Re: 4008688

GREAT SOUTHERN HOMES - SONOMA II B - A2 @ JOINT 4 PLATE REPAIR

Job 4008688	Truss A2	Truss Type Attic	Qty 6	Ply 1	GREAT SOUTHERN HOMES - SONOMA II B - A2 @ T34288905
					Job Reference (optional)

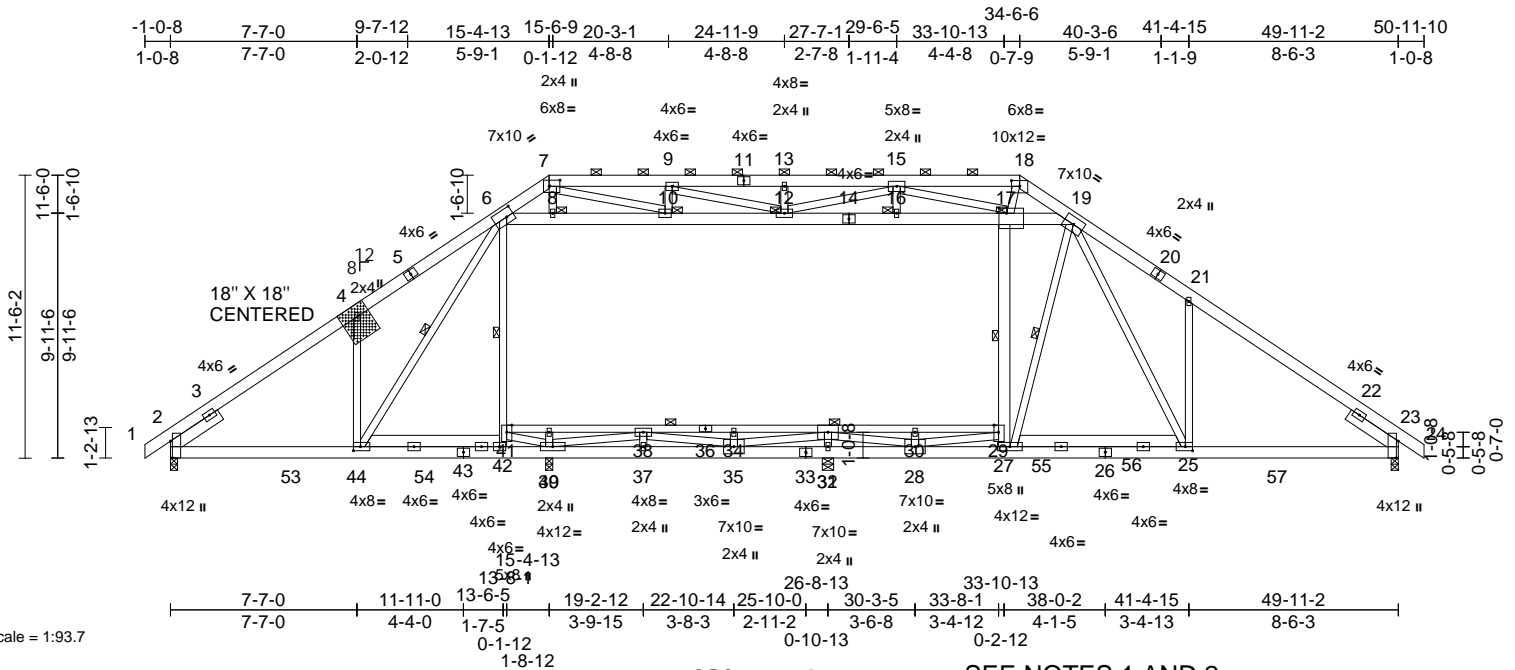
### REPAIR(S) REQUIRED SEE NOTES 1 AND 2.

- NOTES**
- 1) Repair Condition: Missing or damaged plate(s) on one side(s) of truss at joint(s) 4.

- 2) Attach 18"H X 18"W X 1/2" Plywood or OSB (15/32" APA Rated Sheathing 32/16 Exposure 1) gusset to both sides of truss at joint 4 with 8d (0.131"x2.5") nails from each face, driven through both sheets of plywood. Connected together as follows: 2x6 - 4 rows 0-4-0 o.c., 2x4 - 3 rows 0-4-0 o.c. Minimum 0-3-0 end distance.
- 3) N/A
- 4) Unbalanced roof live loads have been considered for this design.
- 5) Wind: ASCE 7-10; Vult=130mph (3-second gust) Vasd=103mph; TCDL=6.0psf; BCDL=6.0psf; h=30ft; Cat. II; Exp C; Enclosed; MWFRS (envelope) exterior zone and C-C Exterior (2) zone; cantilever left and right exposed ; end vertical left and right exposed; C-C for members and forces & MWFRS for reactions shown; Lumber DOL=1.60 plate grip DOL=1.33
